At 529 Congress St.—Alterations for Mines Bros. Co.,

AP 529 Congress St.—Alteration of store front for Kines Bros.

AP 529 Congress St.--Alteration of store front for Rines Bros.

CORNER COLUMN -
ECCENTRICITY ANALYSIS

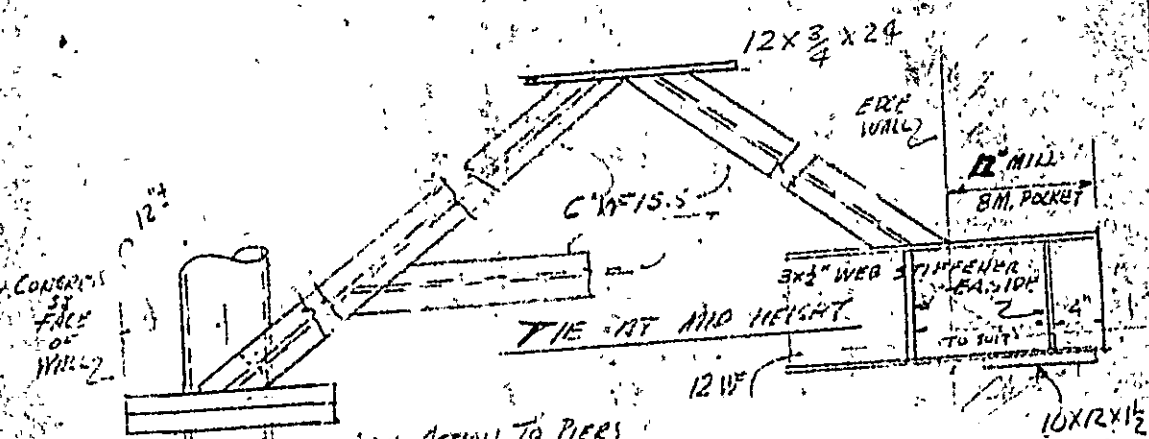
STRUT LOAD
 WITH 5" OFFSET E.C. 5X24 @ 12" - 190,000
 658,000

Less FACIO BEAM E.C. 24" @ 12" - 288,000
 Net Eccentricity 170,000 x 0.8 = 136,000
 10,000
